Request No.: 4

Project Name: Winchester Rd at IL83 Intersection

Subject: Added Ground Improvement Areas

RE: Revision #3 Roadway Foundation Recommendation on Route 83 and Winchester Road Intersection
Project Section 16-00170-13-CH

Exhibit A

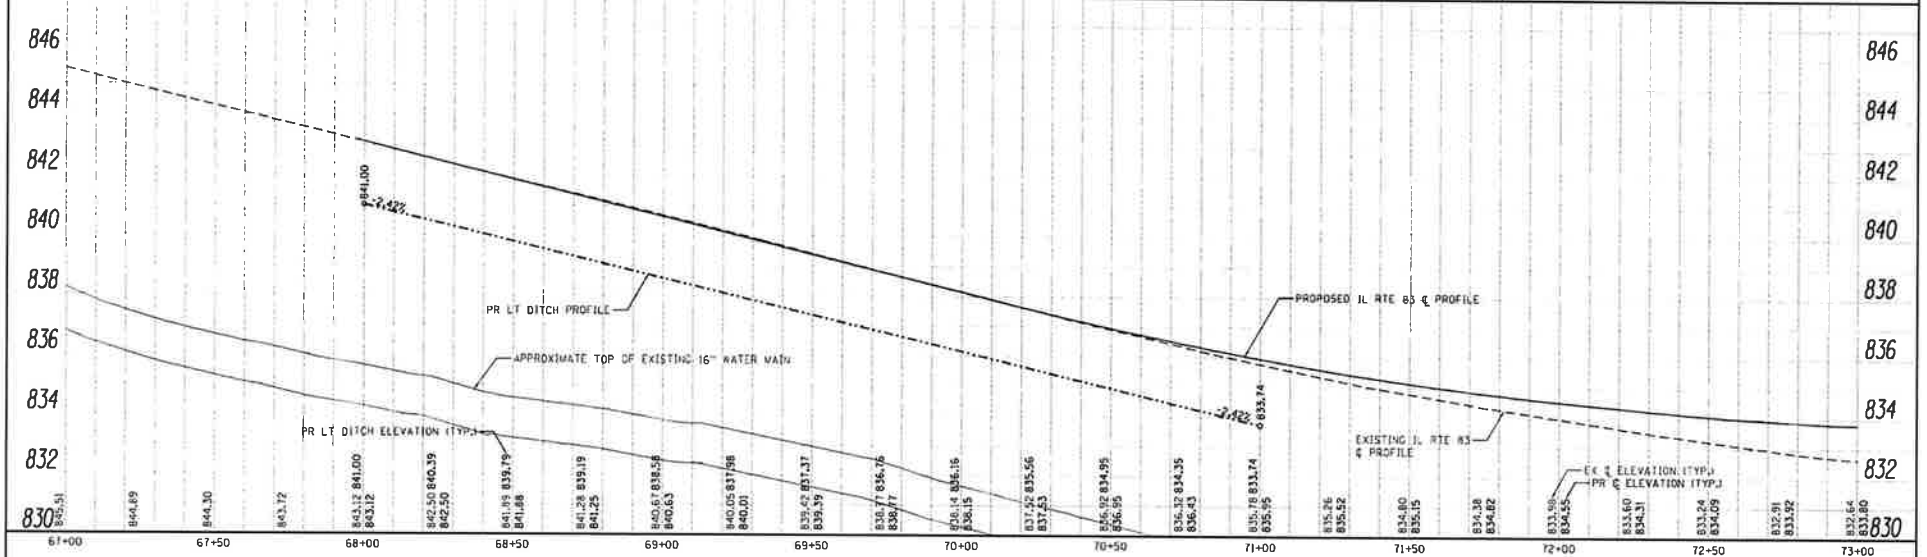
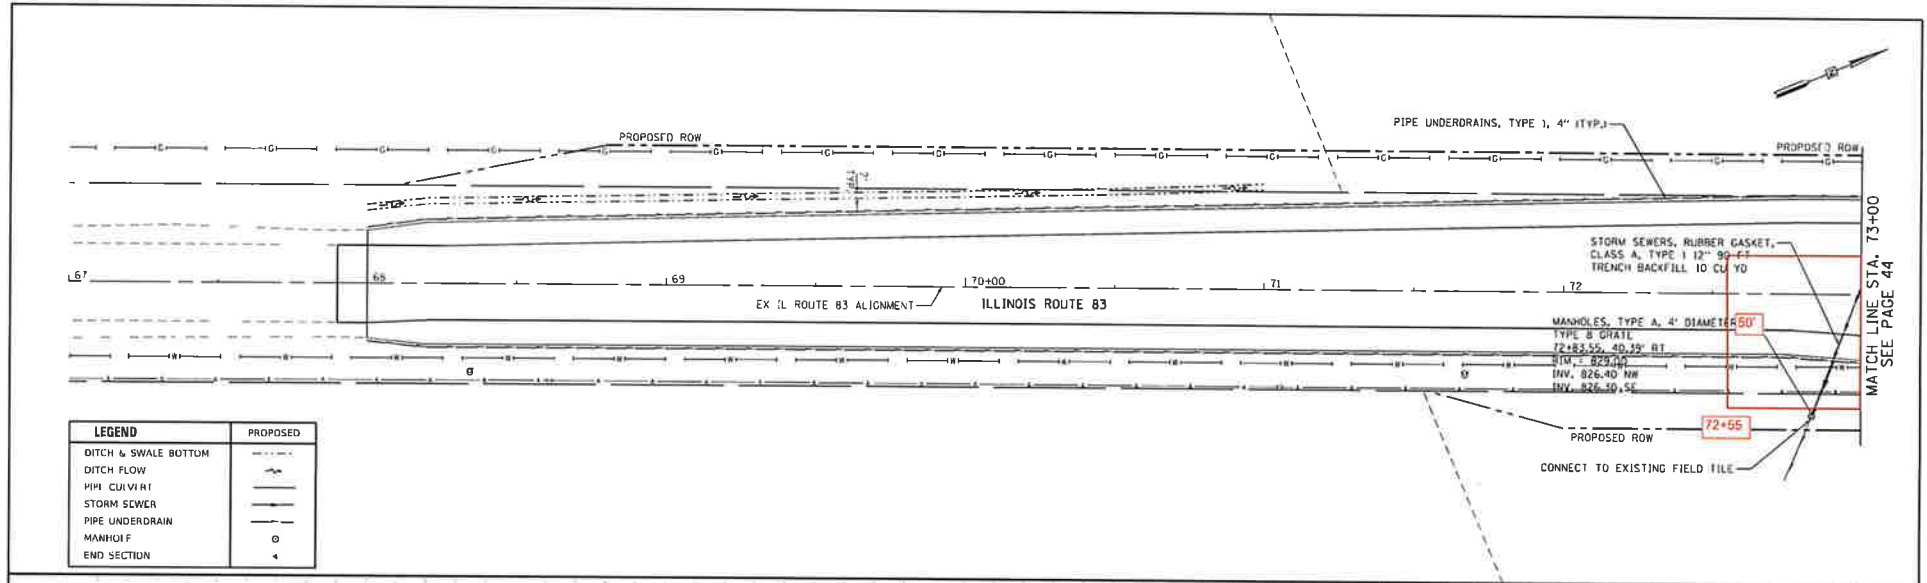
These areas for the geopier alternative will be:

South Side of Box Culvert

South of Culvert Geopiers, Eastside

54' x 30' = 1620 SF

North Side of Box Culvert

150' x 50' = 7500 SF

South Side of Box Culvert

127' x 50' = 6350 SF

Total Square Footage = 15,470 SF

See
Exhibit A

The geopier depths to 3000 psf net allowable bearing will be as follows:

Boring Number	Depth to Bearing (ft)	Approximate Armor Pact Geopier minimum bottom elevation (MSL)
B-1	10'	822.67
B-2	11'	820.80
B-3	15'	816.60
B-4	18'	814.51
B-5	20'	813.22
B-6	16'	817.98
